AURIX™ TC33xEXT errata sheet

Marking/Step: (E)ES-AA, AA

About this document

Figure 2 CAN Frame with DLC > 4

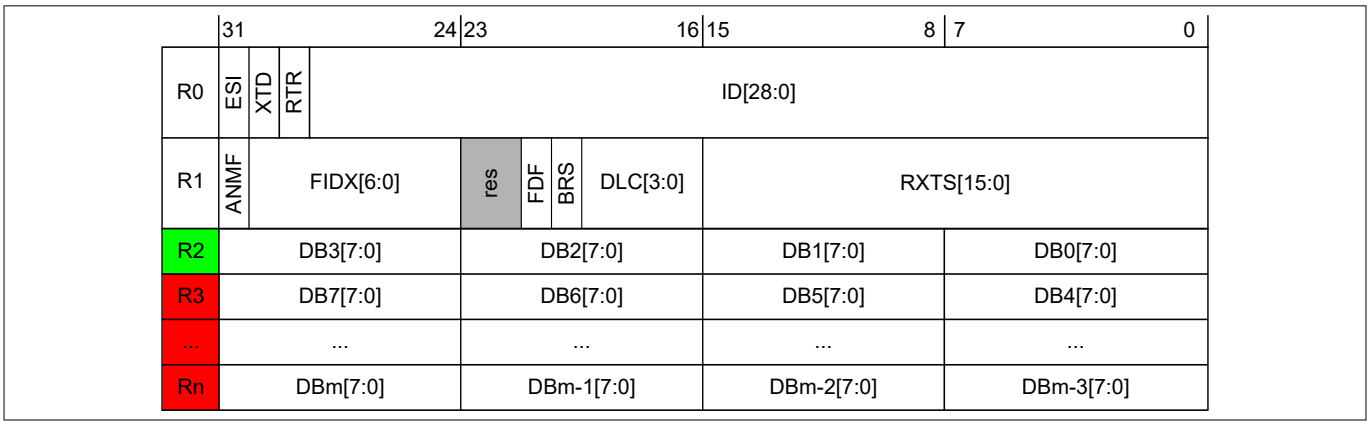
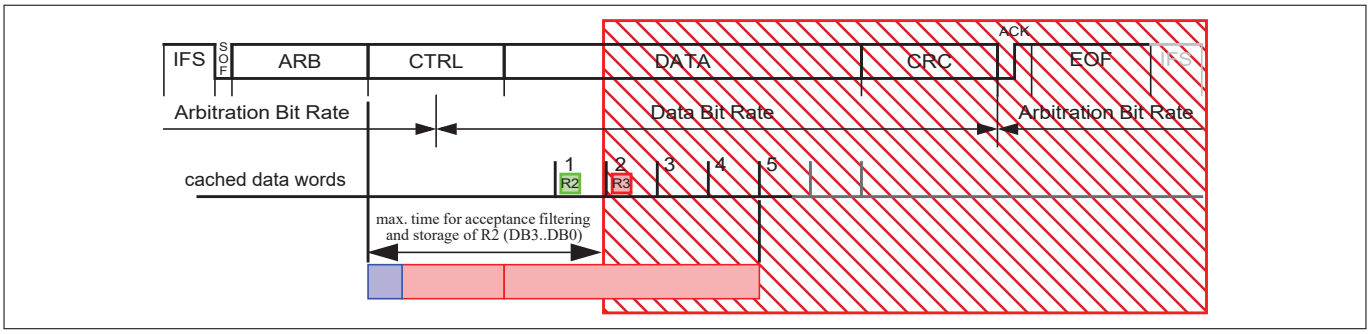
Under the following conditions a received message will have corrupted data while the received message is signaled as valid to the host.

The issue may occur in FD Frame Format as well as in Classic Frame Format.

The figure that follows shows how the available time for acceptance filtering and storage is reduced.

Due to condition 3) the issue only occurs sporadically. Use an end-to-end (E2E) protection (for example, checksum or CRC covering the data field) and add it to all messages in the CAN system, to detect data corruption in received frames.

Figure 3 Positive overload on P-pad of a LVDS RX pin pair (both used as inputs)

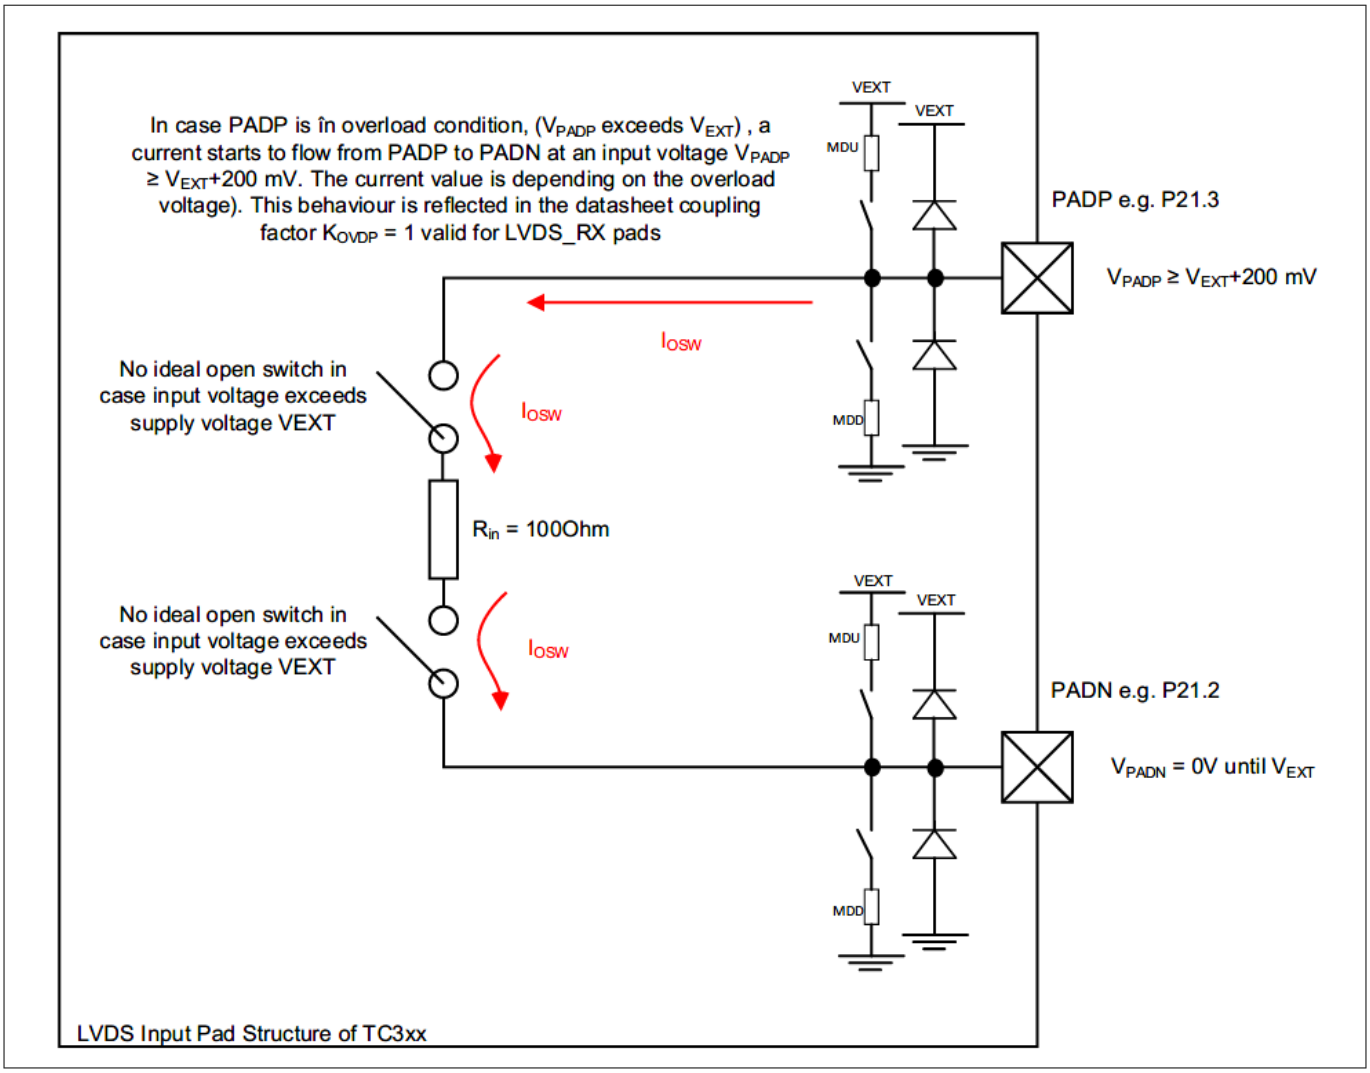
The following figure illustrates the effect for a positive overload condition ($V_{PADP} > V_{EXT}$) on the P-pad (PADP) of a pin pair where both the P-pad and the corresponding N-pad (NPAD, with $0V \le V_{NPAD} \le V_{EXT}$) are used as digital CMOS inputs.

The overload current I_{OSW} through the non-ideal open switch significantly increases when $V_{PADP} \ge V_{EXT}$ + 200 mV.

***Note**: In general, the effect will also occur if the N-pad is used as output, or for a negative overload condition on either the P-pad or the N-pad.*
